PROCEDURE

702
PROCEDURE REVISION REQUEST

PROCEDURE NO. HNP- 8004

E. I. HATCH NUCLEAR PLANT

TABLE 5

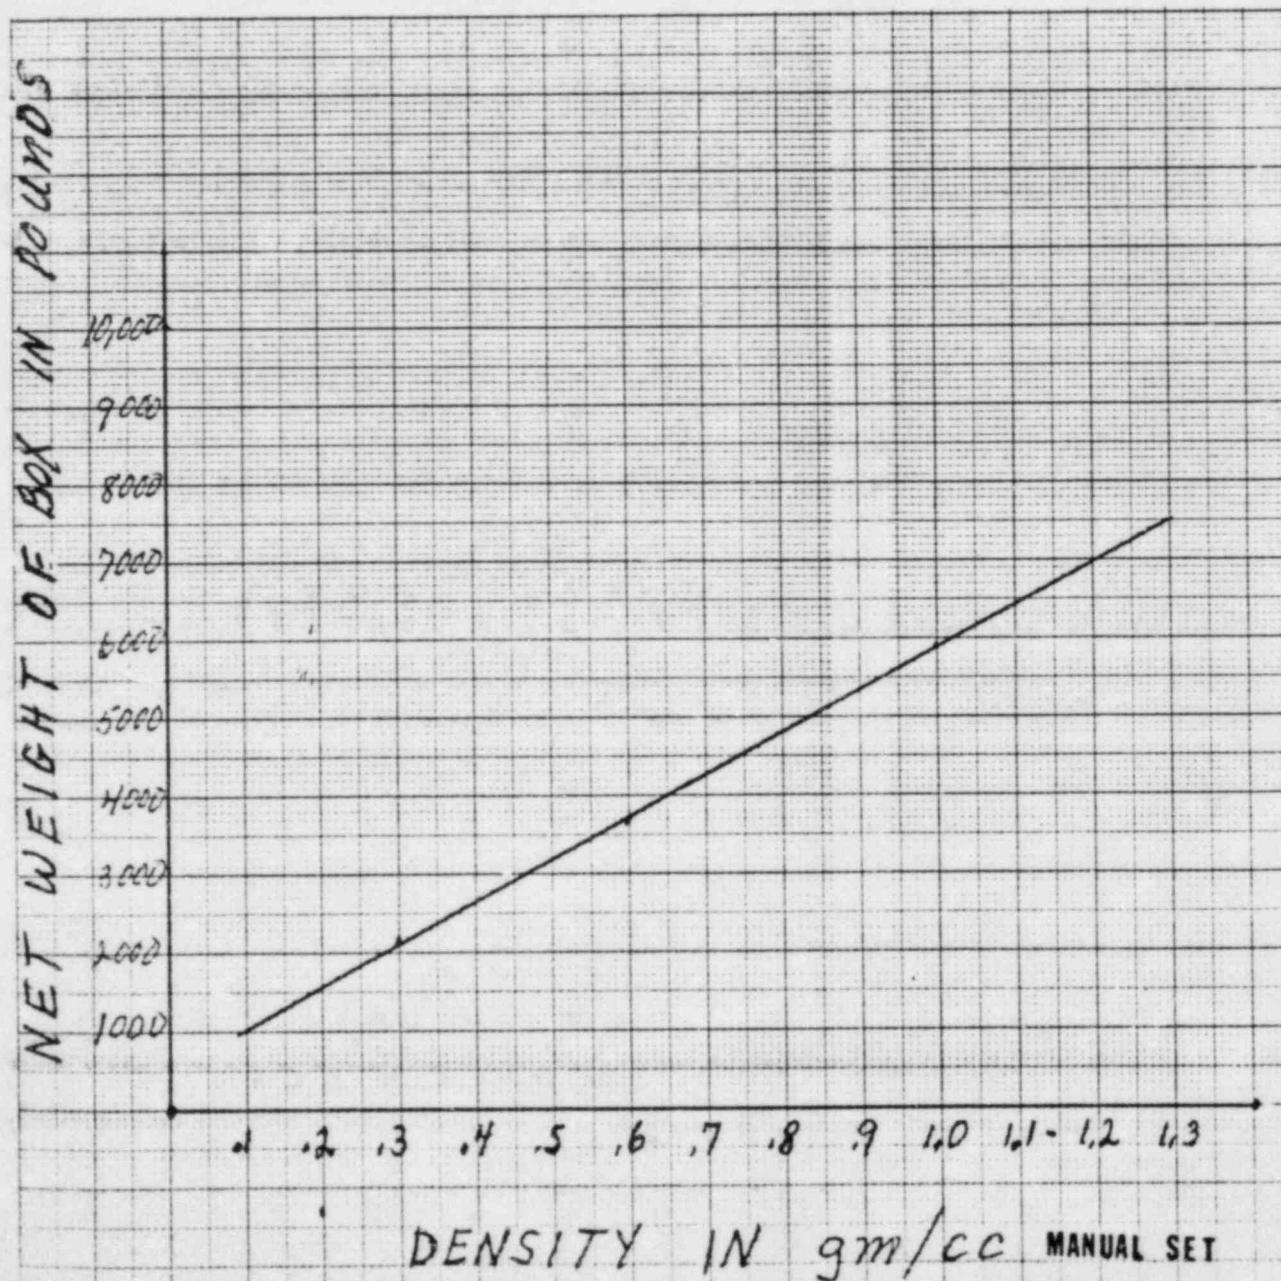
REASON FOR REQUEST Pg 18, para. N.2.c. delete old
formula and substitute a new one
incorporating density factors into
curie determination. Pg. 19 add
Table 5 and density graph. This is
needed to close out Action Item Tracking
number 01915 and associated N.R.R. I.E.R. Report
number 321/82-30.

Density (gm/cc)	Shielding Factor
.3	1.37
.4	1.76
.5	2.30
.6	2.99
.7	3.94
